FM Notification Report Serial Number 10-06

Fairbanks Morse Engine
10CFR 21.21 (d)(3)(ii) Notification

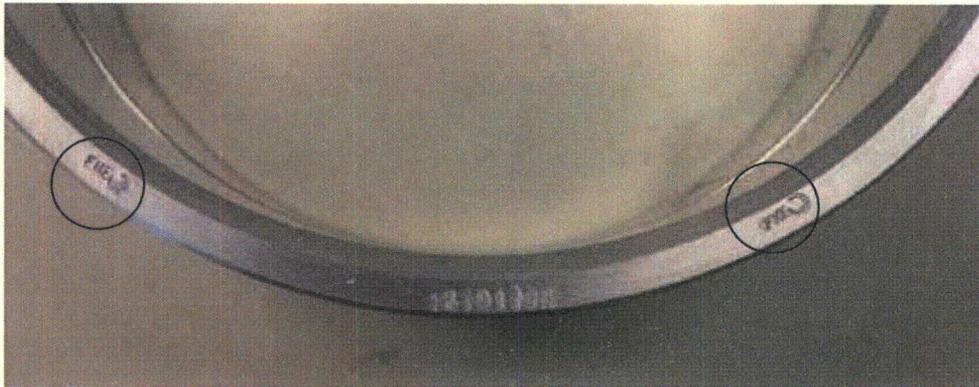
All bearings that are suspect for linear indications are stamped with two FM swirl logos as shown in the photo. Linear indications have only occurred on bearings machined from the latest permanent mold castings which are identified with two FM swirl logos as shown:

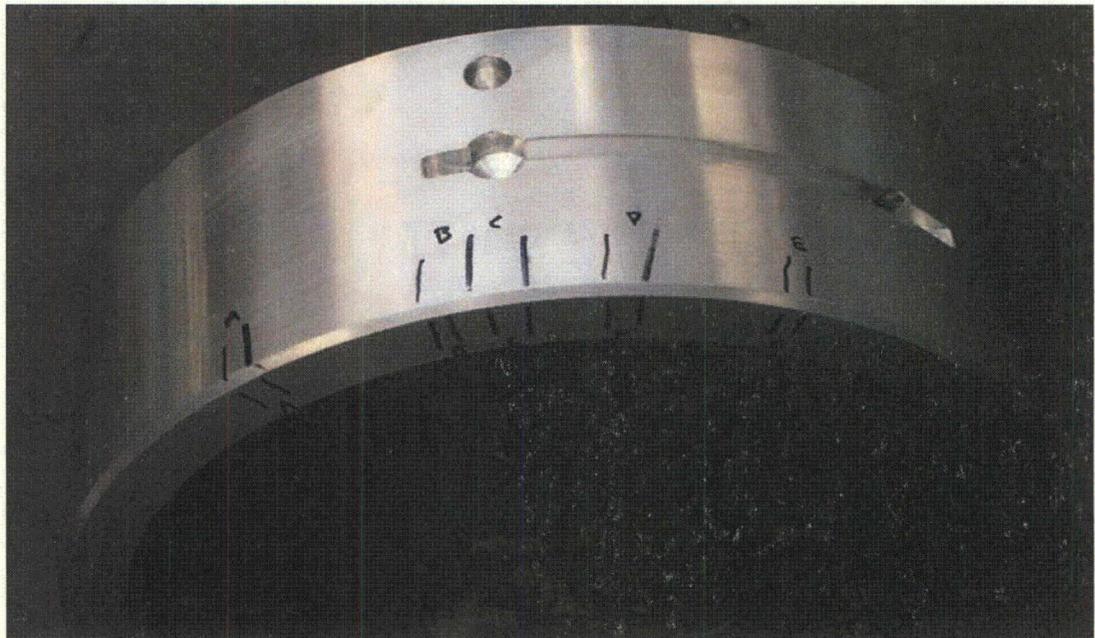
The following photo shows the location of the linear indications marked along one edge of the bearing:

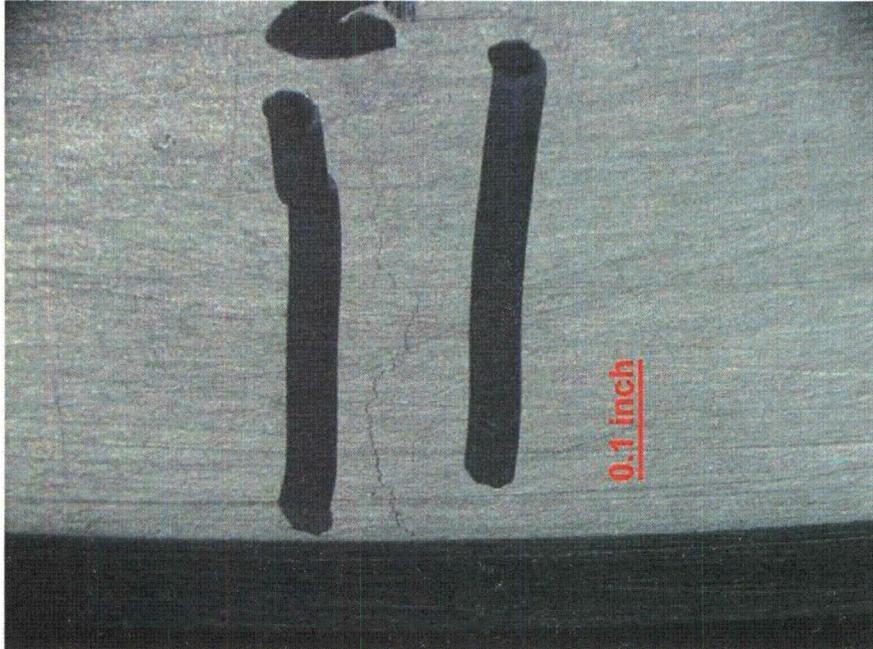
The following photomicrograph at 7X magnification shows a visually apparent linear indication:

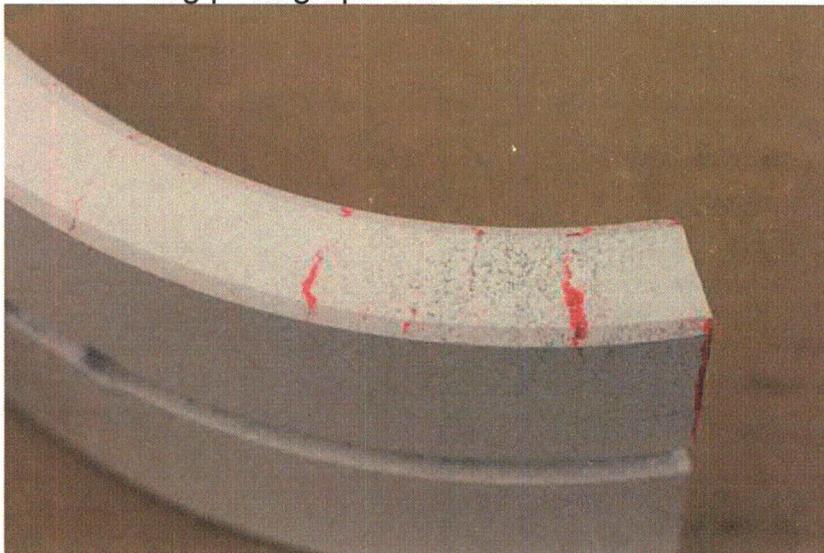
The following photograph shows linear indications observed by PT:

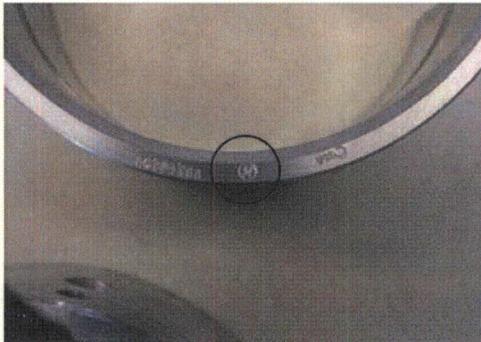
Effective February 7, 2011, FM is performing PT inspection on all aluminum OP bearings to verify there are no linear indications. Bearings that are accepted are being stamped with an "M" inside of a circle as shown in the following photo:
